Lower Yonge Precinct

Municipal Class Environmental Assessment Study
Consultation Summary from the Public Information Centre

Lower Jarvis Street: Queens Quay – Lake Shore Blvd (Facing North)
3-Lane + Bi-Directional Cycle Path (26.00m R.O.W.)

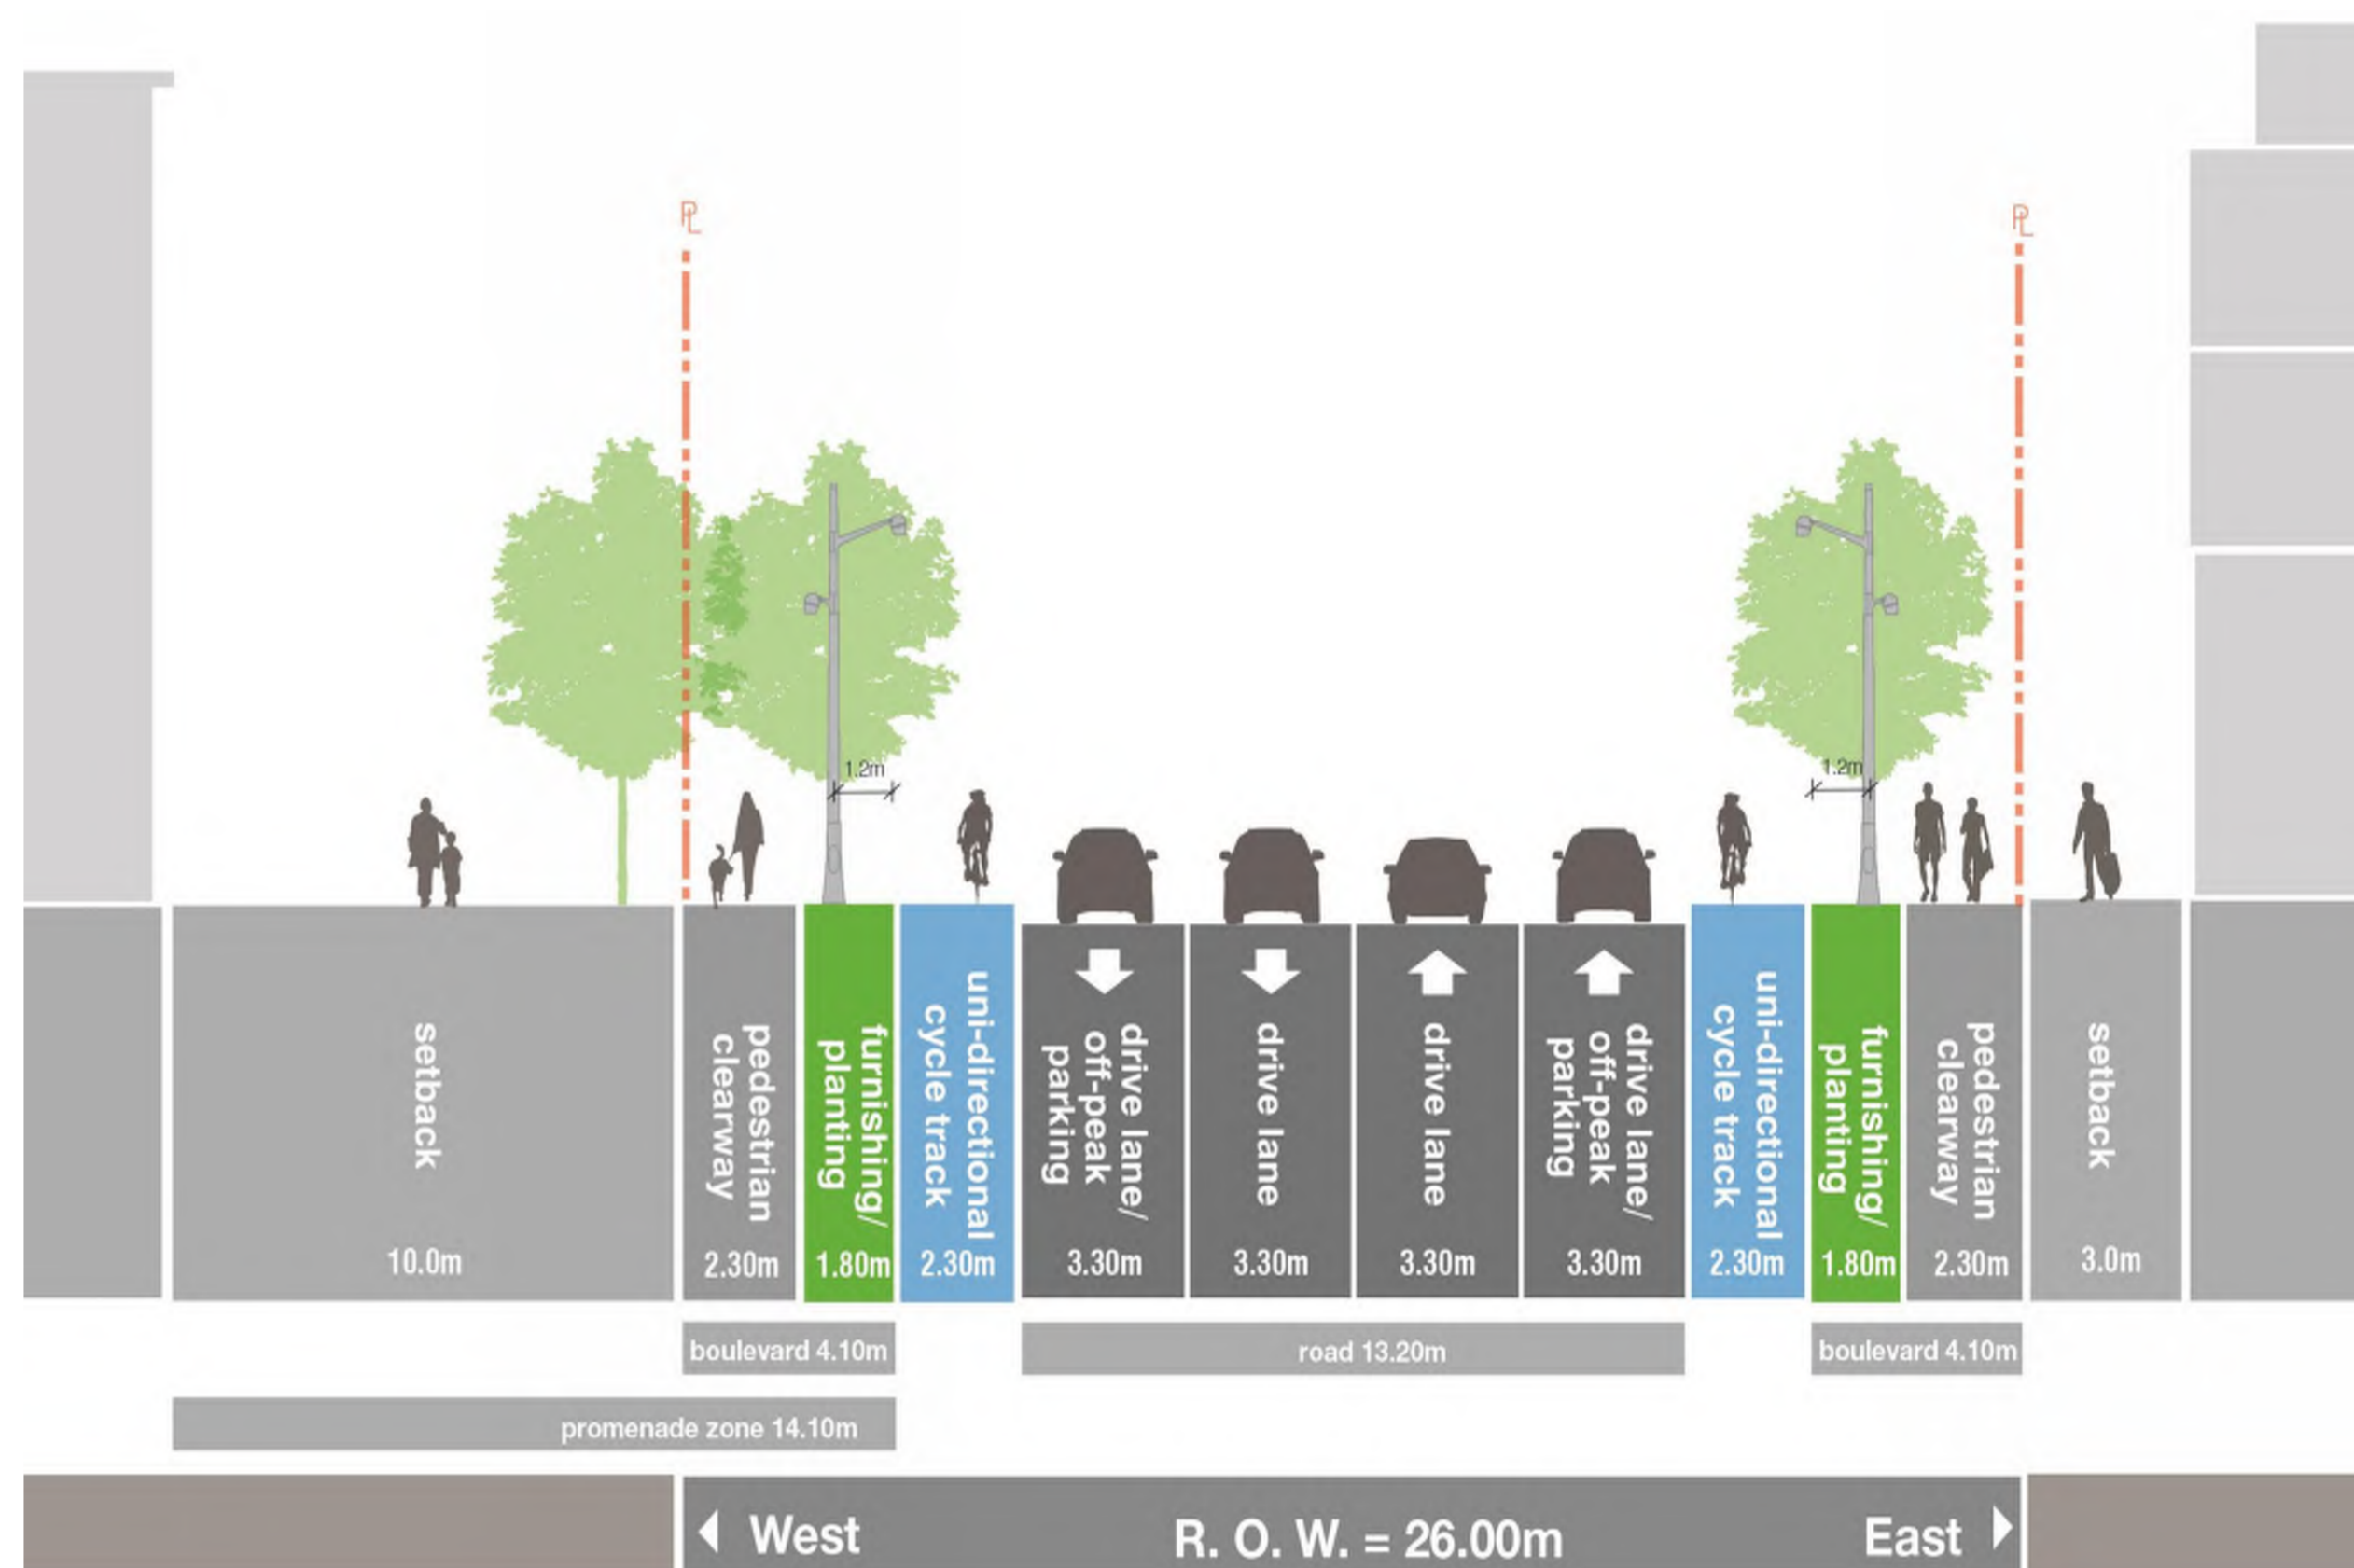
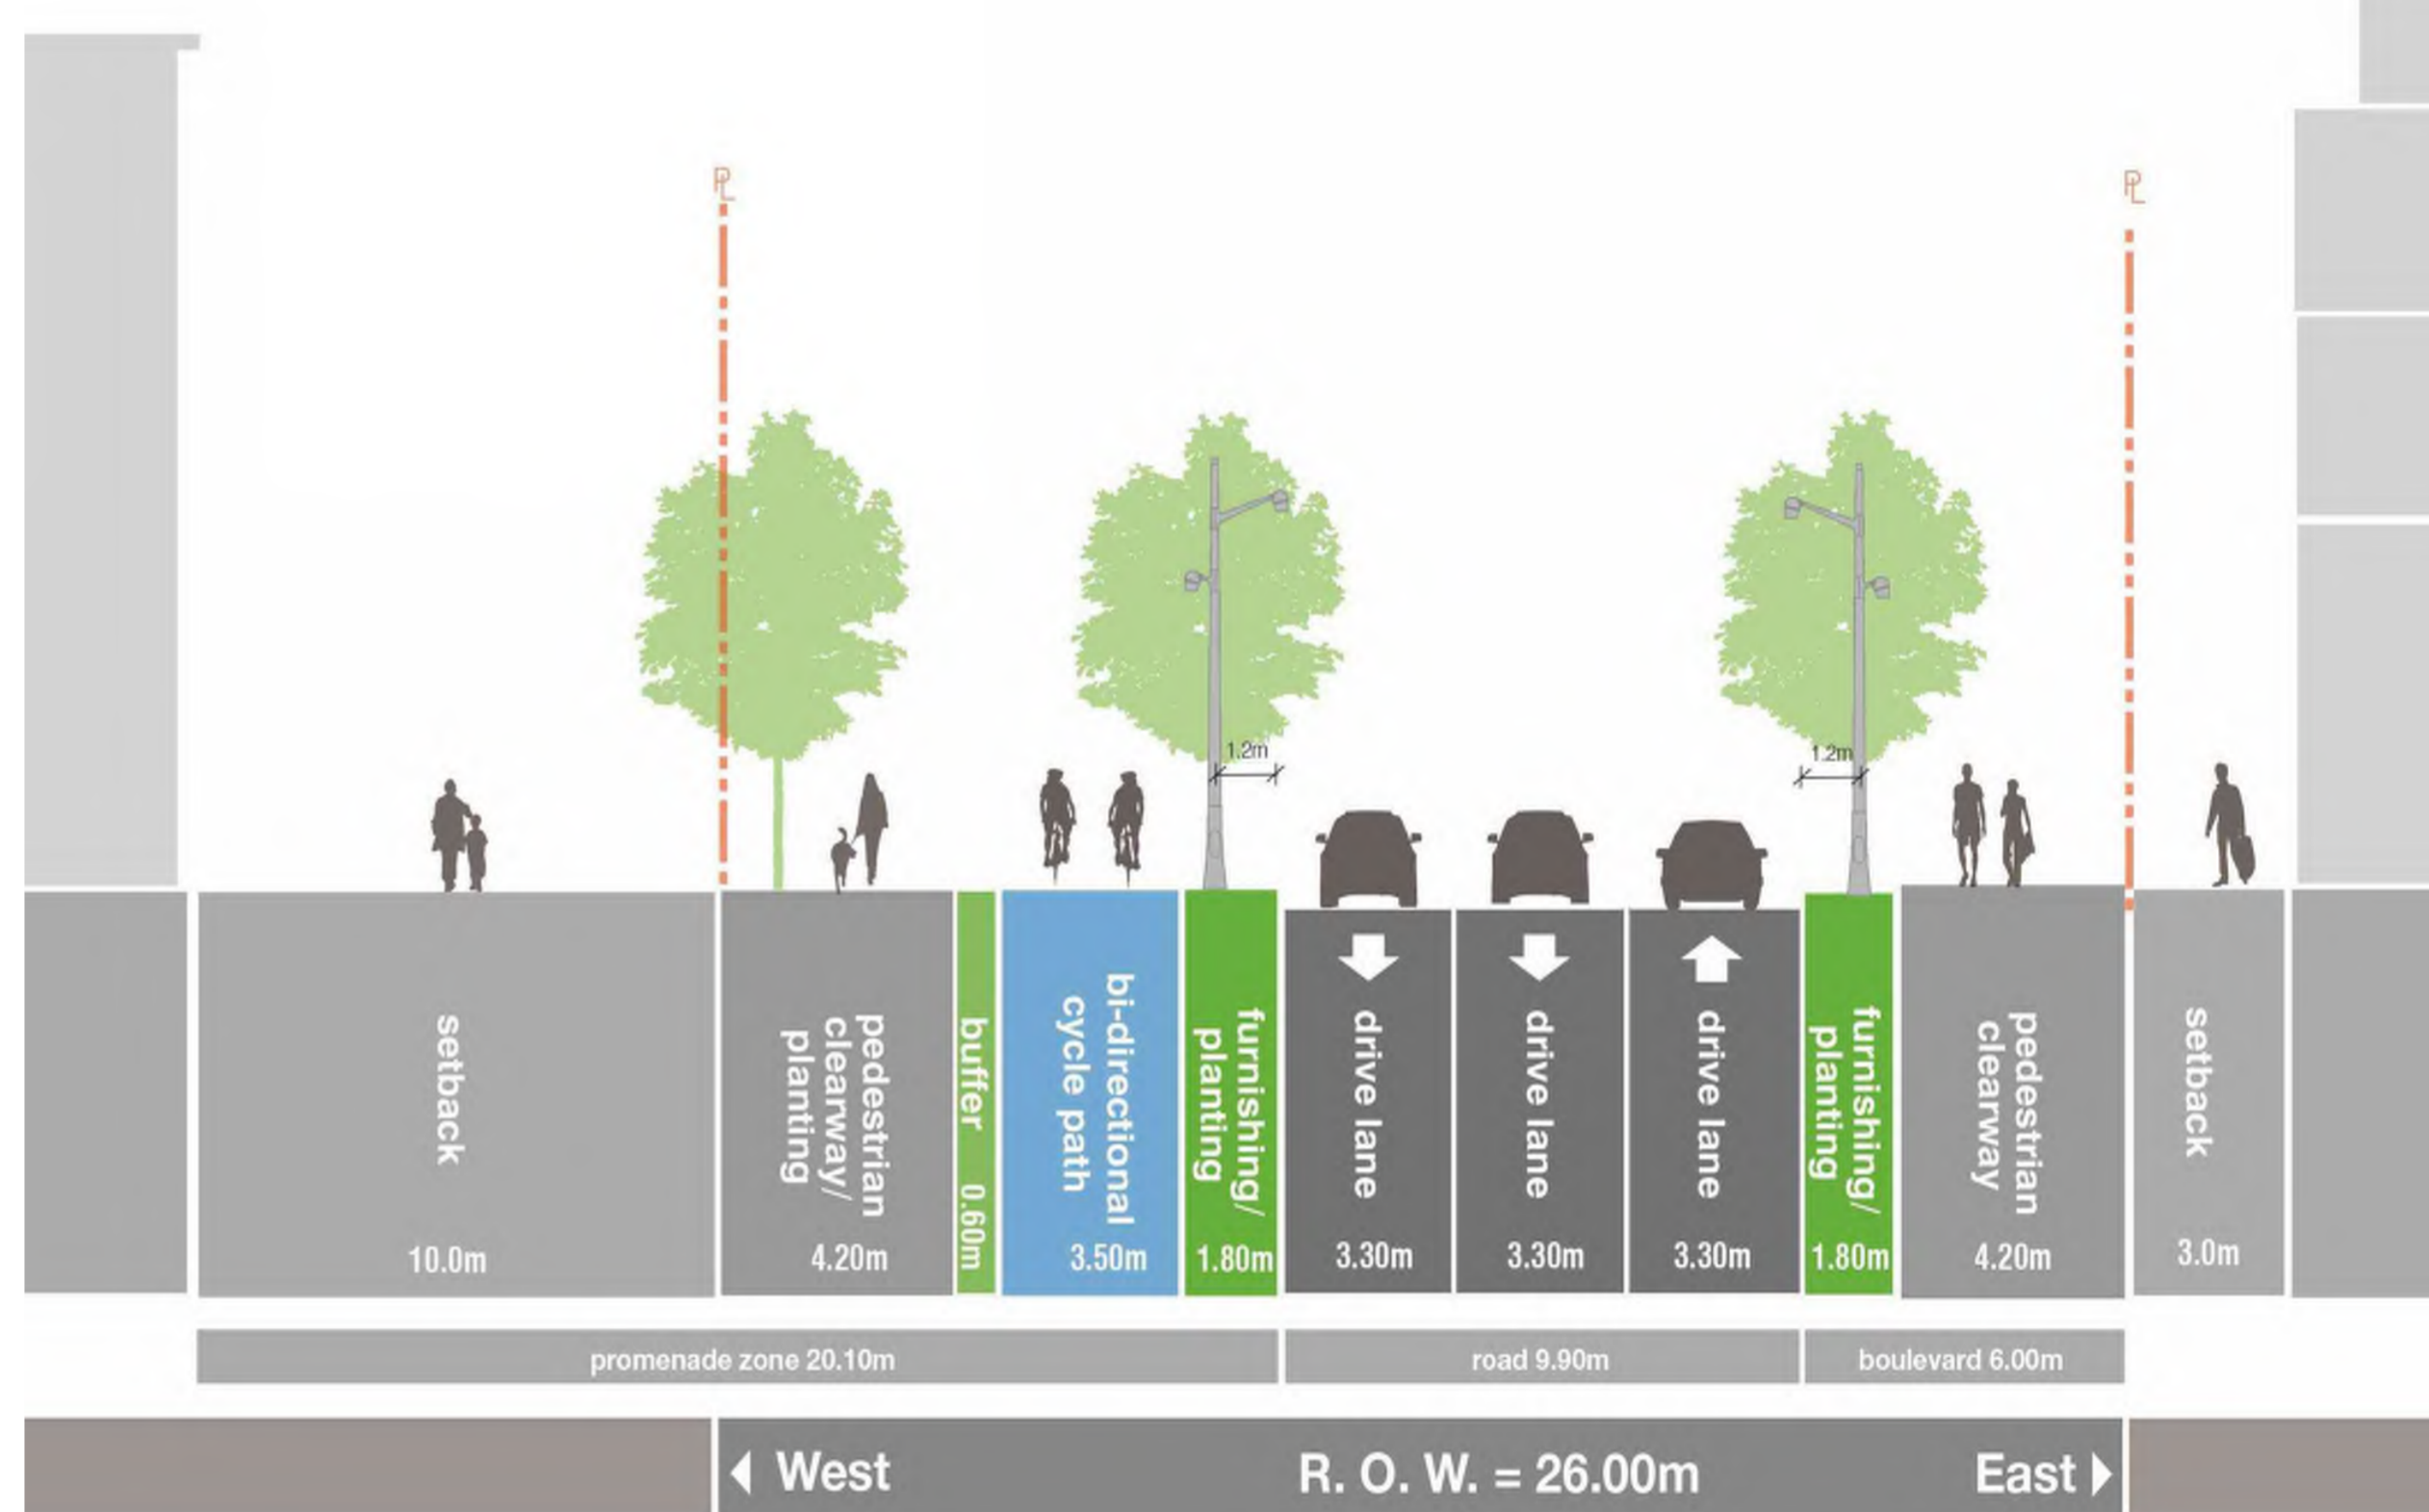
Square curbs alone don't provide adequate separation between cyclists and vehicles; can bollards be provided?

The proposed cycling facility for Lower Jarvis Street includes a physical separation (raised curb) which provide adequate separation between different modes of transportation, including pedestrians and cyclists. Bollards are not recommended at this location due to the limited right-of-way and future maintenance concerns.
